Editor comments

Reviewer #1

Reviewer #2

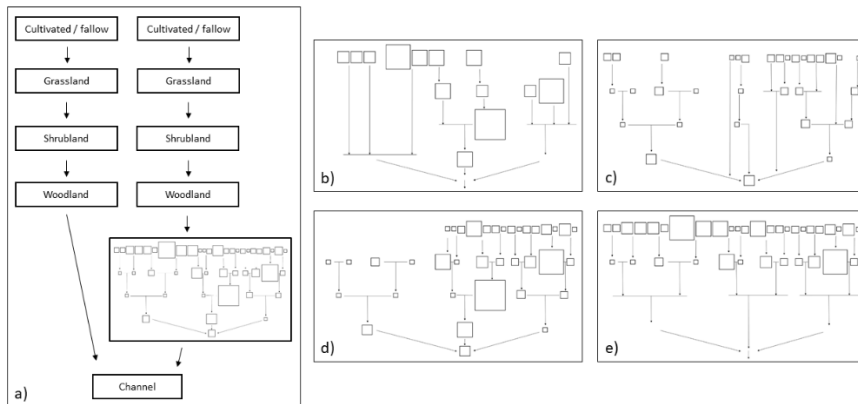
Comment – please revisit how the term “drainage” is used throughout the paper (e.g. line 659) since the term drainage typically refers to the movement of water through a watershed, but here it is mostly used to refer to the action of draining wetlands.

We address this comment by adding a sentence in Section 2.6 – Drainage scenarios that specifically states: “In the context of this paper the term “drainage” refers to wetland drainage; the act of removing surface water storage capacity from depressions, and not the movement of water through a basin.”
